Proposed Technical Specifications Change No. 28

North Anna Power Station Unit No. 1

SAFETY ANALYSIS FOR REVISED
CONTROL ROD INSERTION LIMITS FOR NORTH ANNA UNIT 1

Figure 3.1-1 Rod Group Insertion Limits Versus Thermal Power

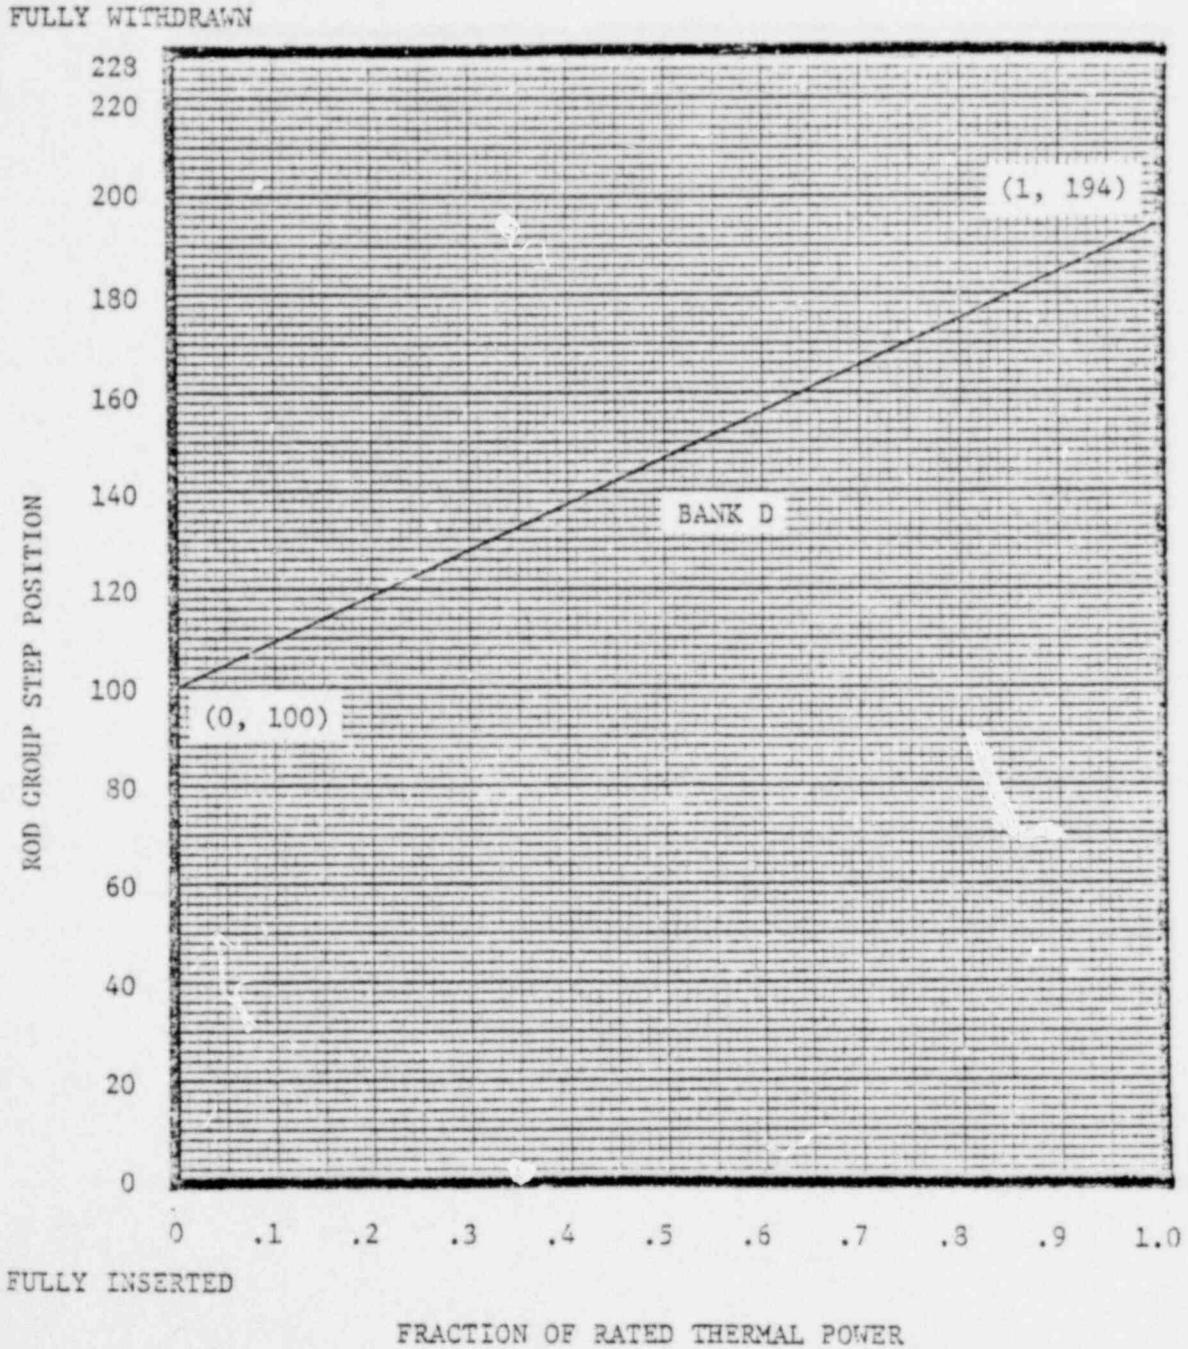
Additional analytical simulation of the tilted condition in Cycle 2 was performed in order to a) provide a basis for revising the control rod insertion limits and b) generate core physics input required to support a safety evaluation of the impact of the power tilt on the postulated accidents presented in Chapter 15 of the FSAR. Based on this analytical simulation, a new and very conservative set of control

rod insertion limits was developed and administratively imposed. These new limits were verified by measurement at several power levels during the unit startup physics testing program. In addition, these newly imposed limits were developed consistent with the commitment made in Reference 1.

An explicit assessment of the impact of the observed (beginning of life) and analytically predicted (end of life) Cycle 2 core power tilt on all of the accidents postulated in Chapter 15 of the FSAR (Reference 4) has been made. This assessment assumes operation within the revised control rod insertion limits shown in Figure 1. In addition, the impact of a postulated coolant flow and temperature imbalance (a potential cause of the tilt) was determined.
